Subject: College Park Elementary School HVAC Replacement
San Mateo - Foster City School District
Aedis Project No. 2021005.01
DSA Application #01-119530

ADDENDUM NO. 1

College Park Elementary School HVAC Replacement
San Mateo – Foster City School District
Aedis Project No. 2021005.01

1 NEW FLOOR PLAN - WING 4
SCALE: 1/8" = 1'-0"

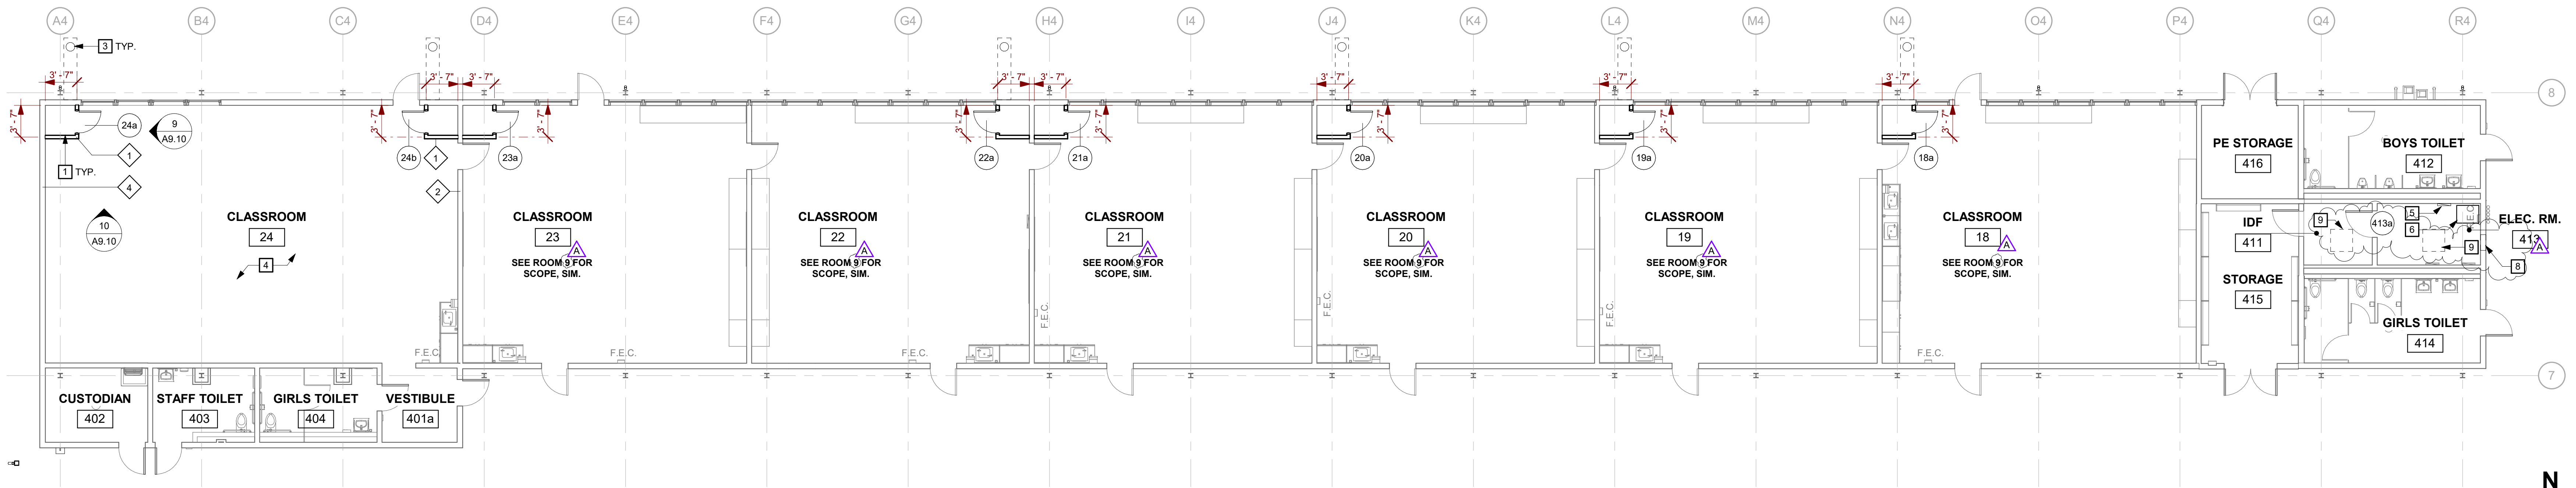
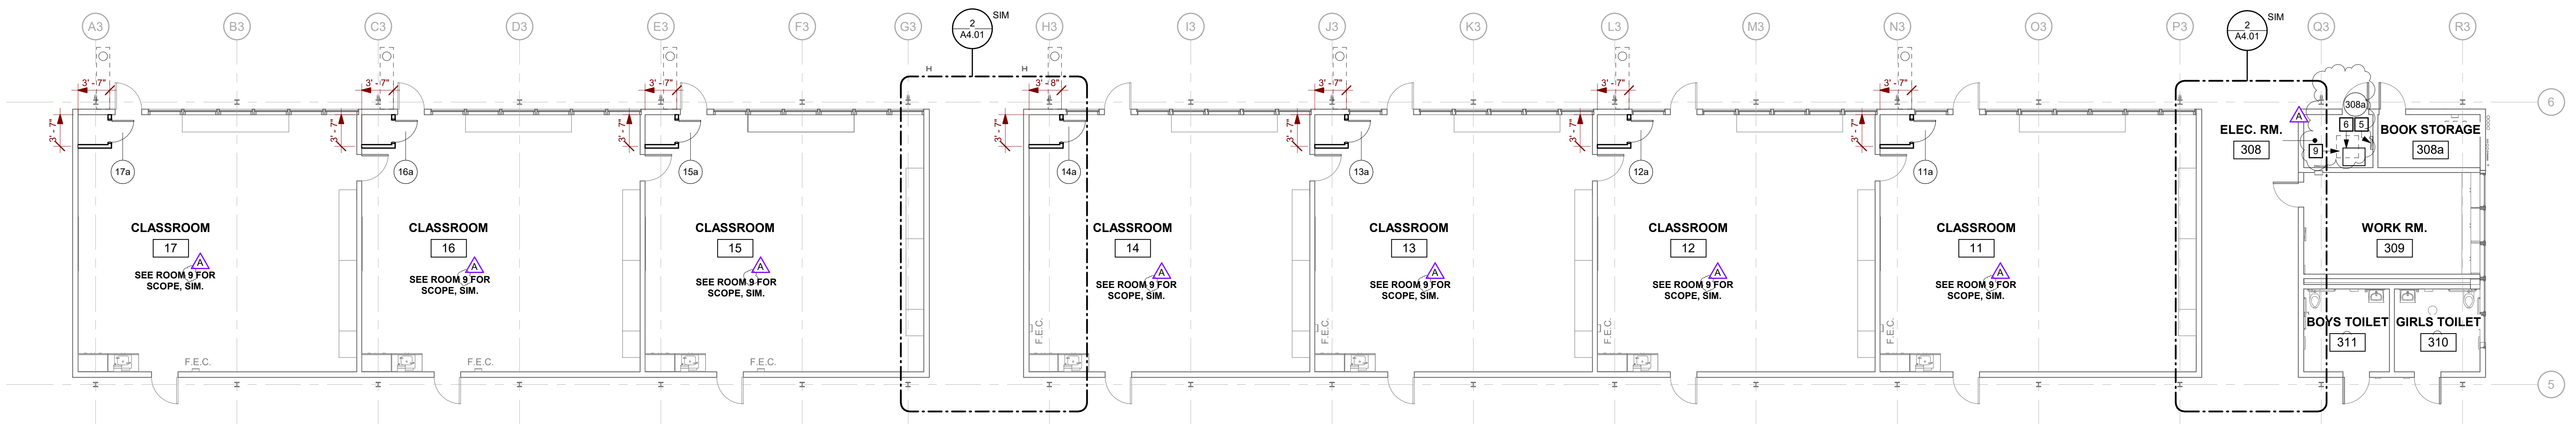
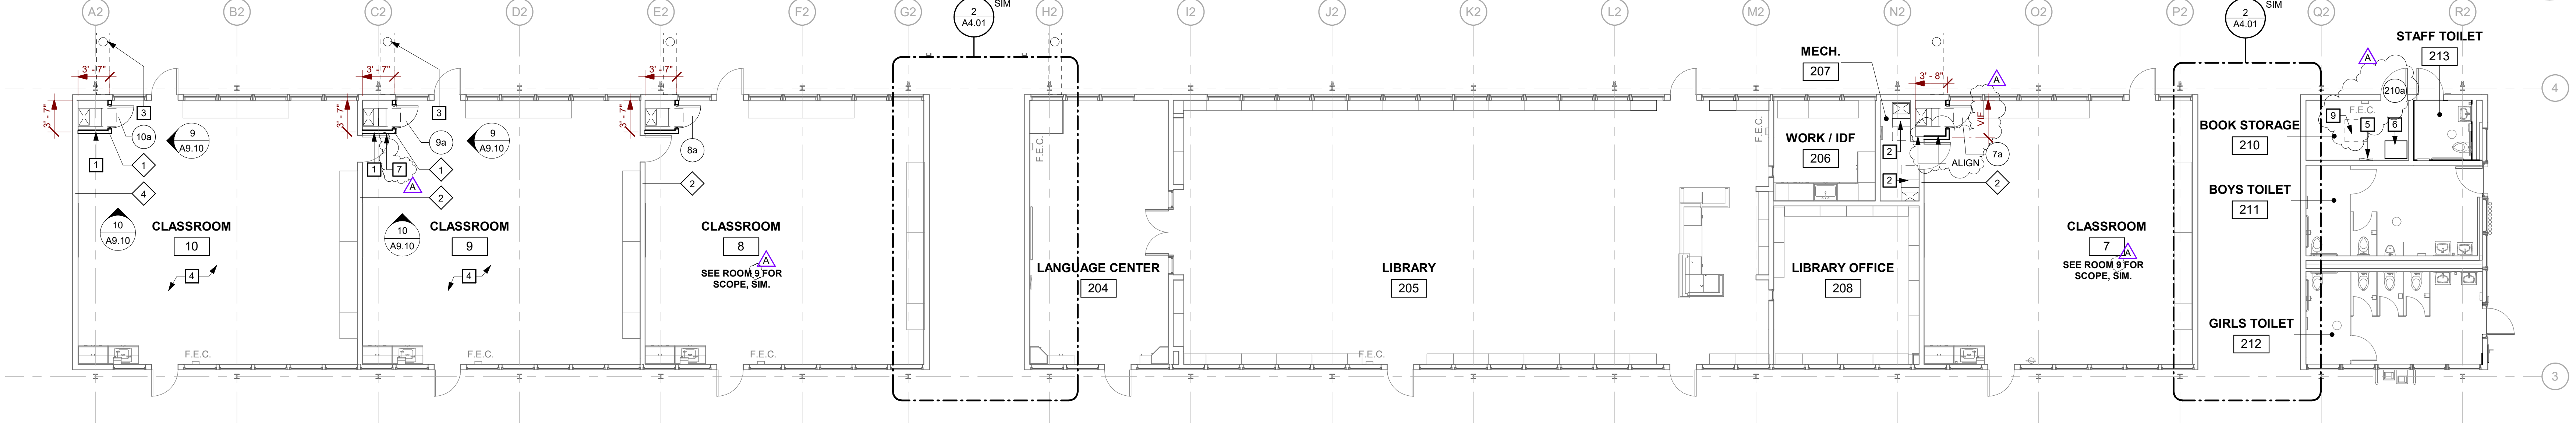
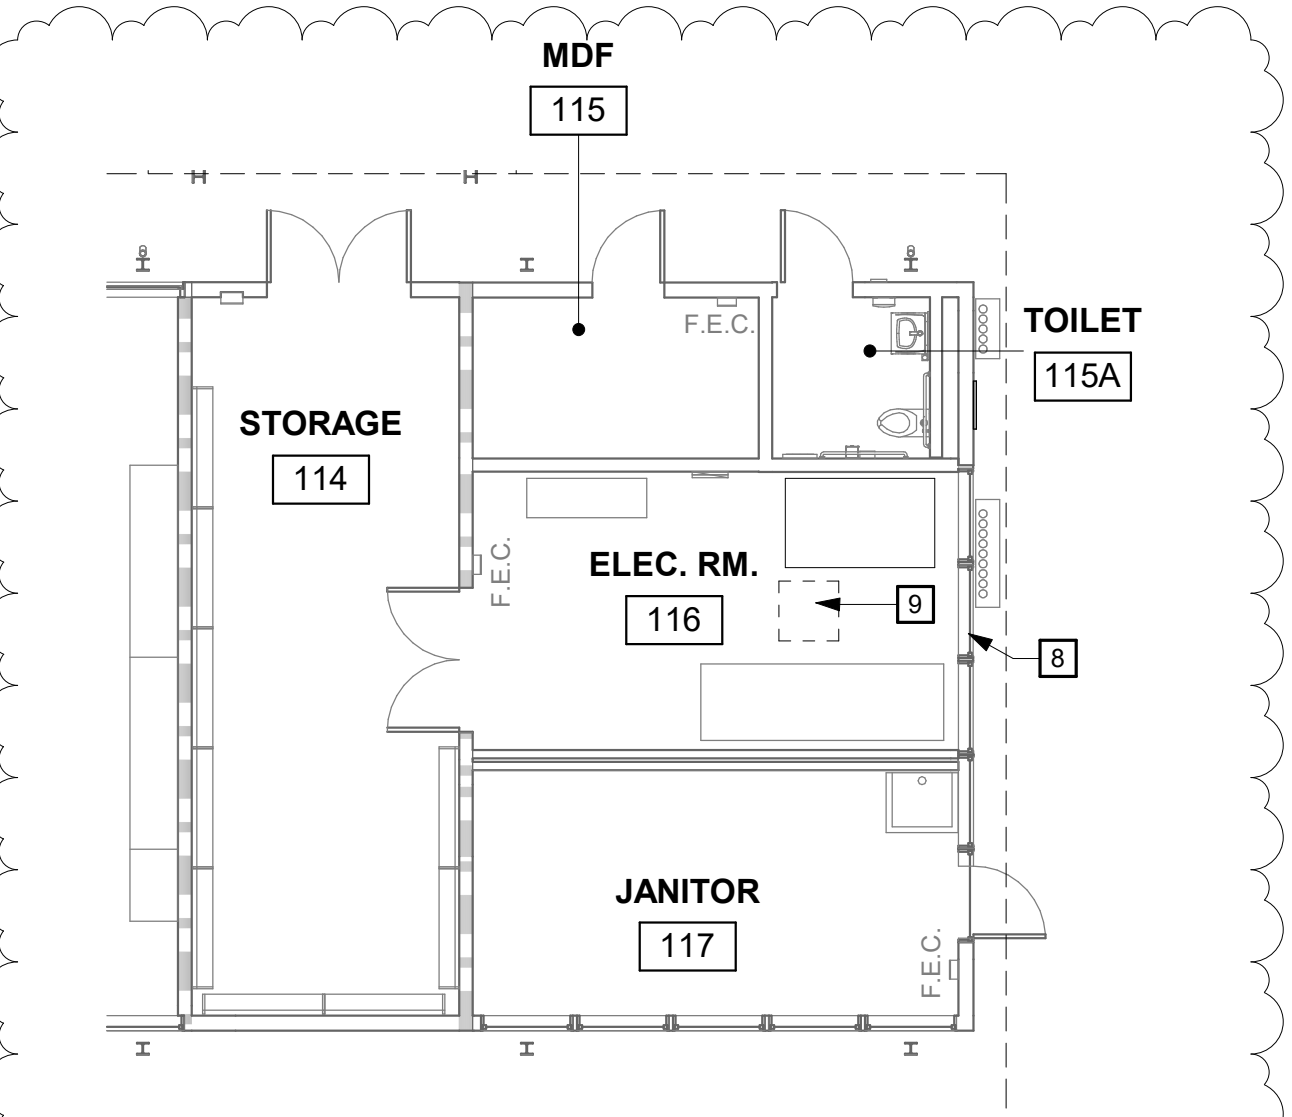
Revise: Reference room 9 for similar scope where occurs in New Floor Plans 1/A3.01, 2/A3.01, and 3/A3.01 per AD1-A3.01
Revise: Dimension and alignment at room 7 in New Floor Plan 3/A3.01 per AD1-A3.01
Add: Door stop keynote #7 to New Floor Plans 1/A3.01, 2/A3.01, and 3/A3.01 per AD1-A3.01
Add: New Floor Plan Keynotes #7, #8 & #9 per AD1-A3.01
Add: Louver keynote #8 to New Floor Plan 1/A3.01 per AD1-A2.01
Add: Ceiling patching keynote #9 in New Floor Plans 1/A3.01, 2/A3.01, and 3/A3.01 per AD1-A3.01
Add: Door tags 210a, 308a & 413a in New Floor Plans 1/A3.01, 2/A3.01, and 3/A3.01 per AD1-A3.01
Add: View 4/A3.01 Partial Floor Plan – Wing 1 per AD1-A3.01
Revise: Keynote 4 per AD1-A3.01

1 PARTIAL SITE ROOF PLAN
SCALE: 1/16" = 1'-0"

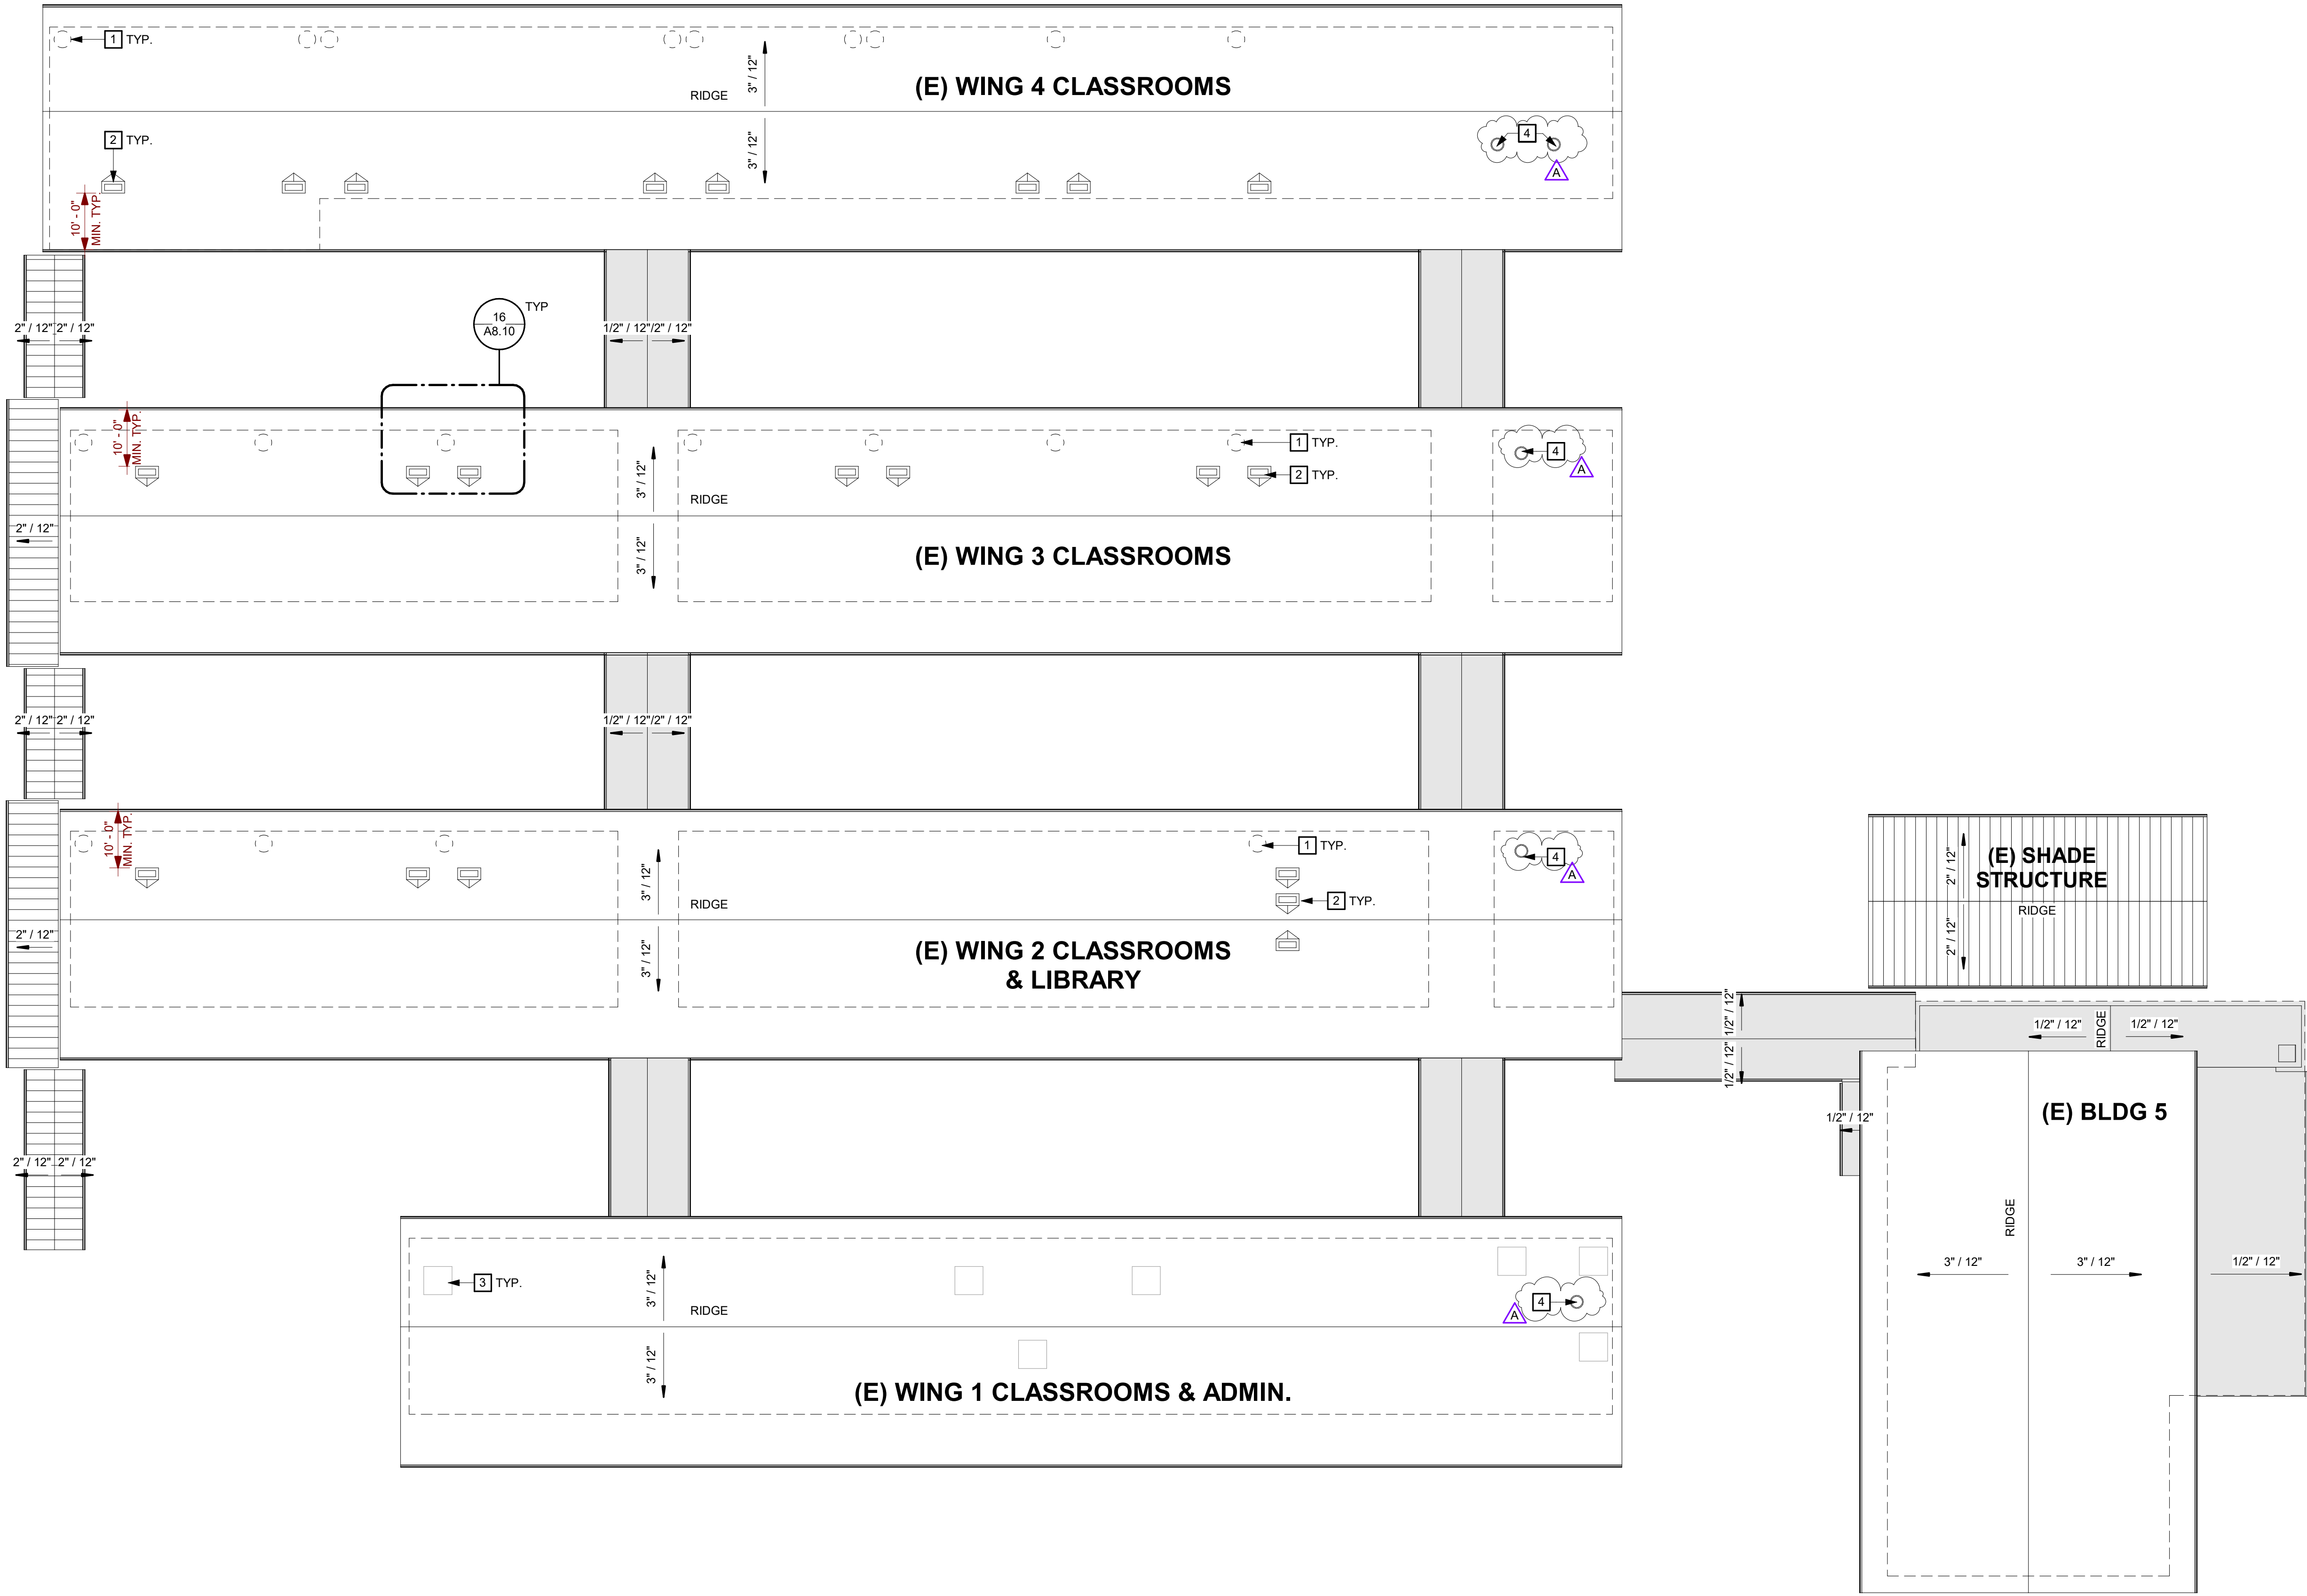
Add: Roof Exhaust Fans per AD1-A5.01
Add: Roof Plan Keynote #4 per AD1-A5.01

ASPHALT/CONCRETE JOINT

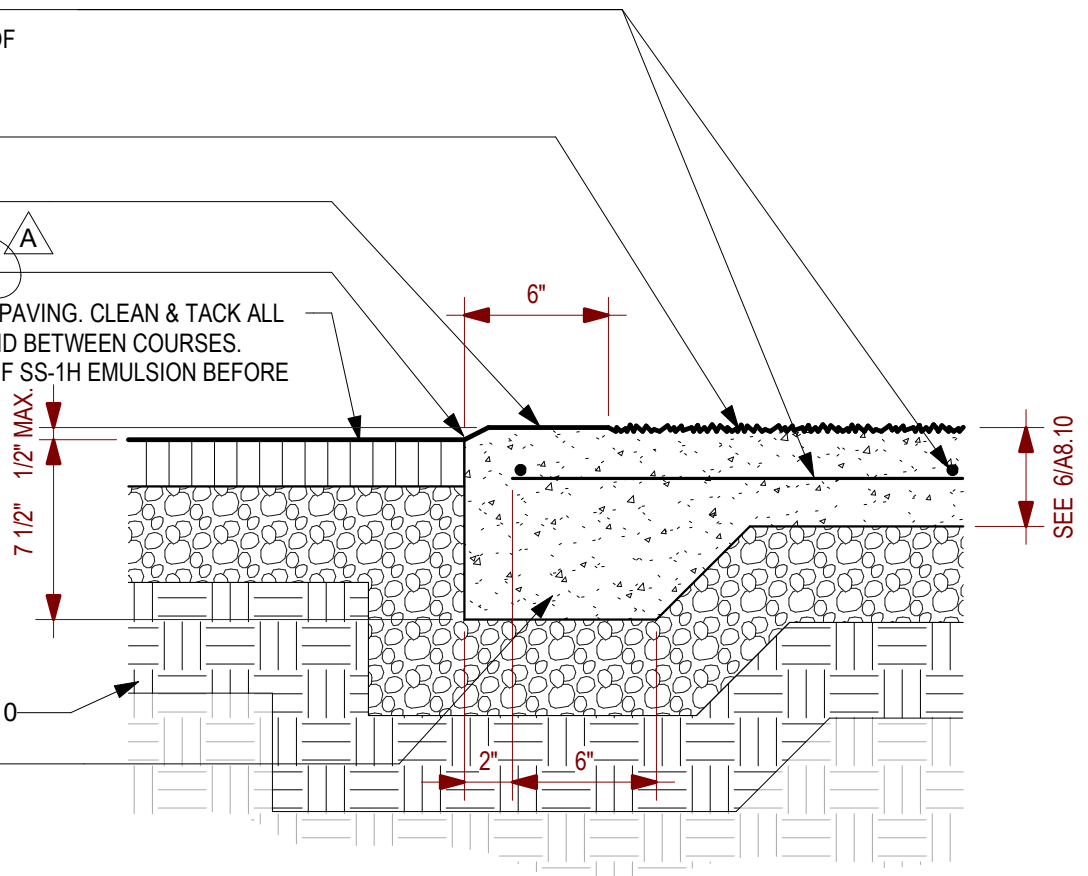
Revise: Detail 9 per AD1-A8.10

WALL TYPE - MECHANICAL ENCLOSURE

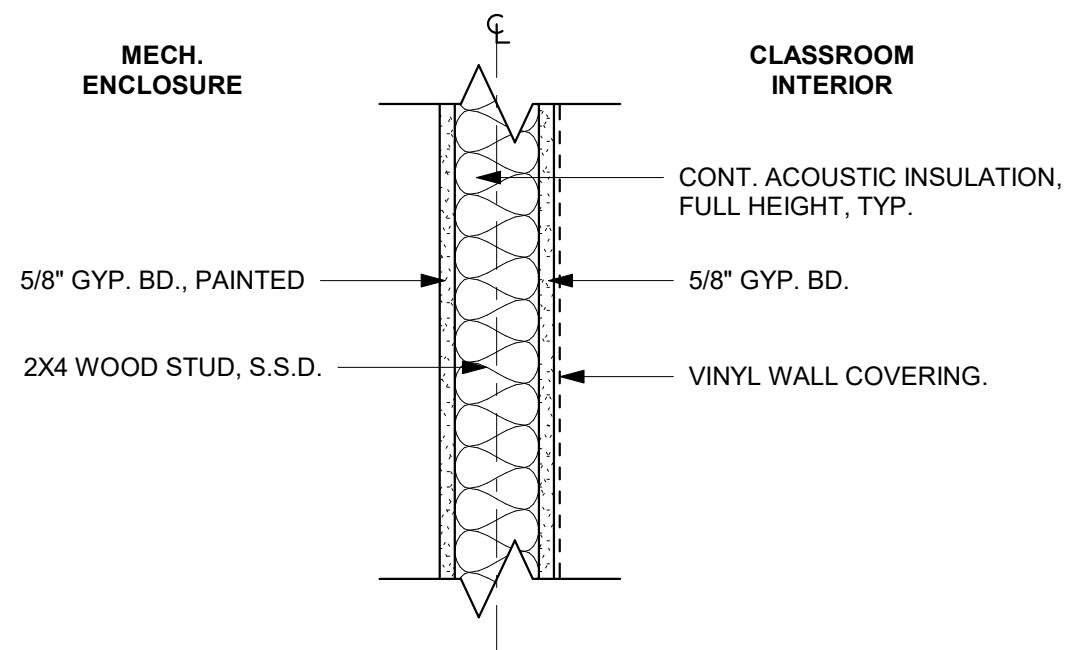
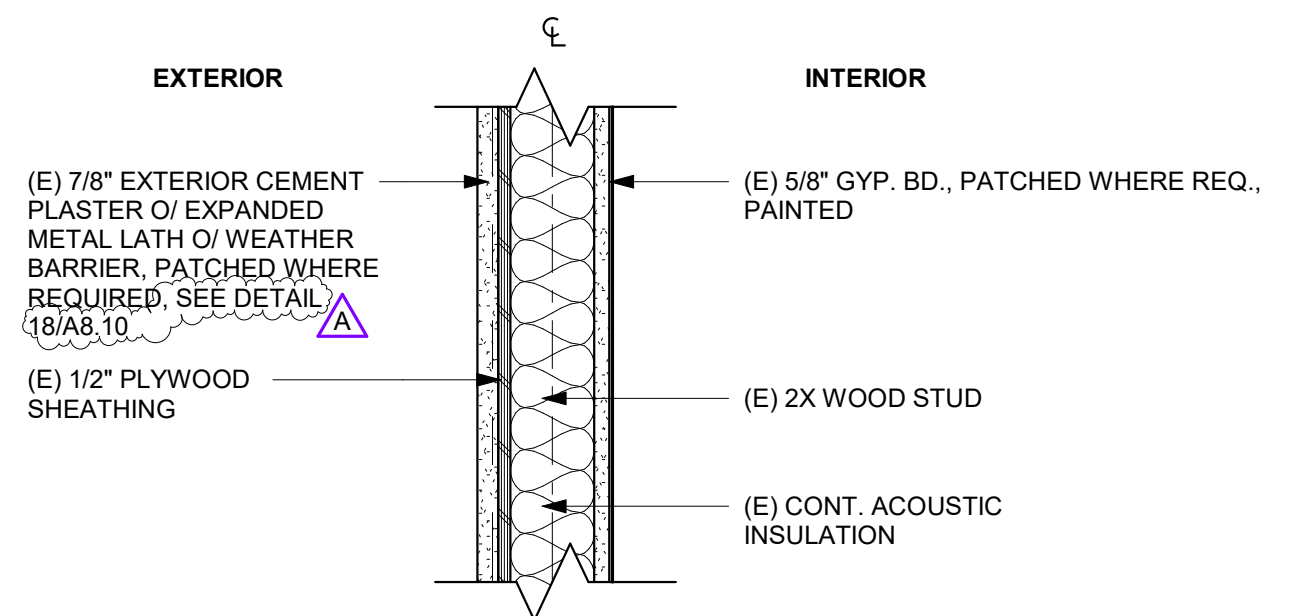
Revise: Details 1 & 3 per AD1-A9.10A
